## INSERTION INSTRUCTIONS FOR AMENDMENT 2

MNPS-3 EROLS

INSERTION INSTRUCTIONS FOR NRC QUESTIONS AND RESPONSES

## EROLS QUESTIONS

FIGURE QE 291.12-1  
SITE PLAN  
MILLSTONE NUCLEAR POWER STATION  
UNIT 3  
ENVIRONMENTAL REPORT  
OPERATING LICENSE STAGE

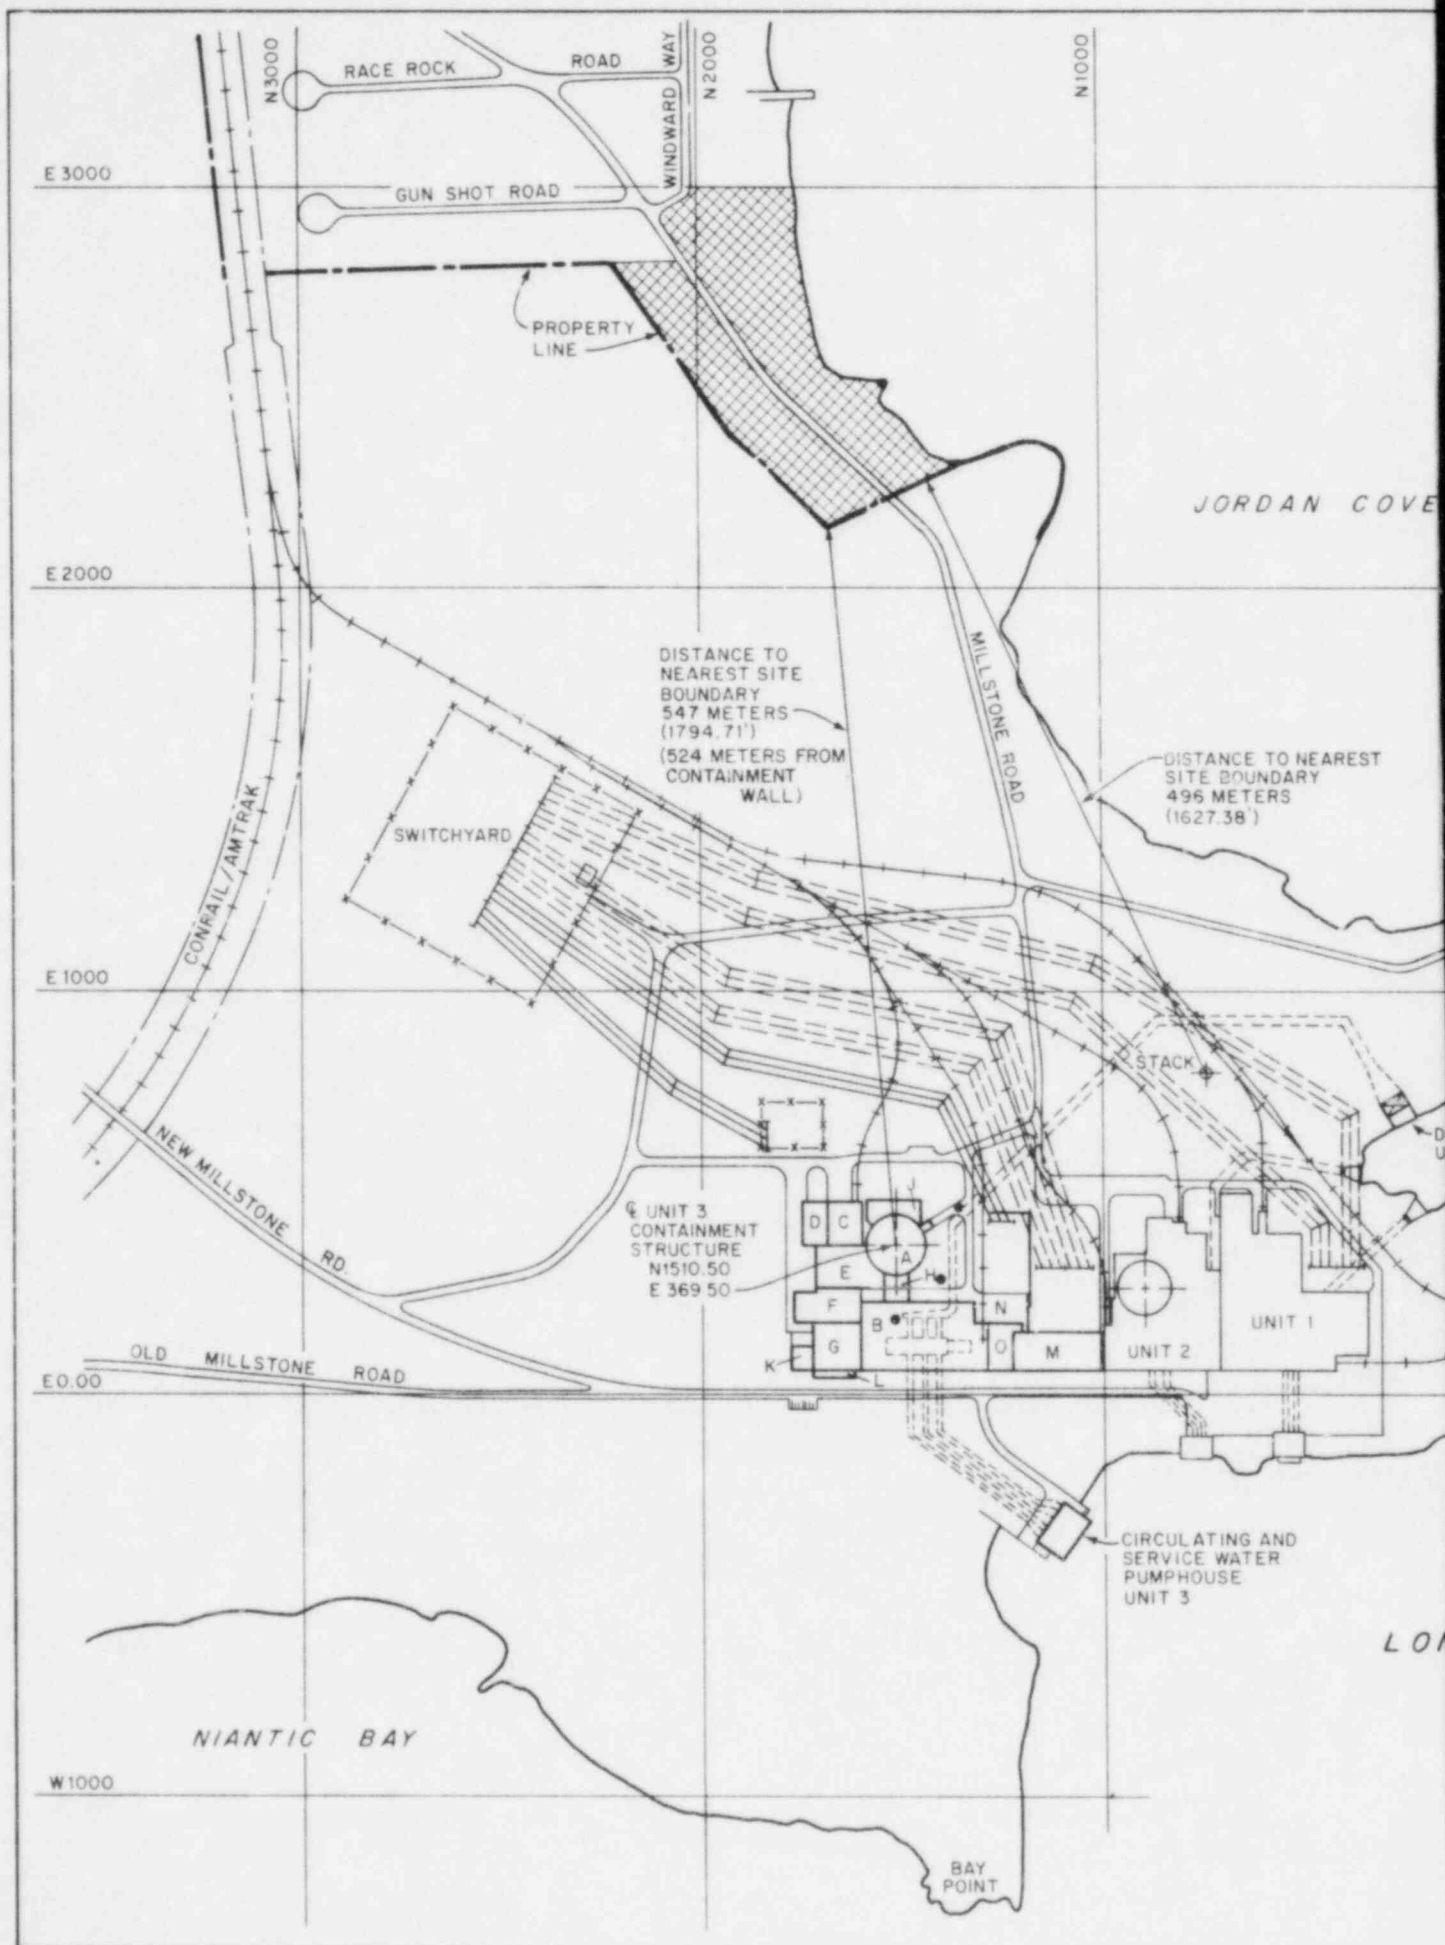
Indicate the location, physically in relation to the Unit 3 discharge structure, where the service water mixes with the circulating water. Section 3.6 indicates that the biocide control point is to be here, but Section 5.3 indicates that the control point is to be where the mixed waters enter the quarry. Indicate which situation is correct.

Figure QE291.12-1 shows the physical location, in relation to the Millstone 3 discharge structure, where the service water mixes with the circulating water.
